RIGGING ADVISORY CIRCULAR

RAC No. 407 Rev. A

SUBJECT MIRAGE CONTAINER MODIFICATION

IDENTIFICATION Mirage Container System built by Sky Supplies, built before April 1, 1983.

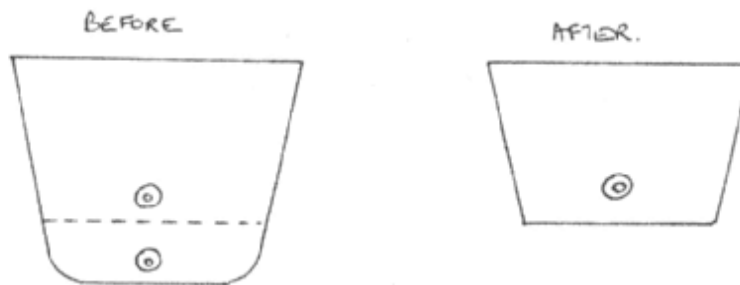
The change involves shortening the kicker flap as shown in the sketch below.

PROCEDURE Measure down 7 inches from the tip of the inner #1 kicker flap. Use a heavy pair of shears to remove the bottom of the flap (including the bottom grommet).

Sear the edge of the fabric with a hot knife and bind the exposed edge with $\frac{3}{4}$ " type 3 nylon tape (MIL-T-5 038), matching the existing construction method.
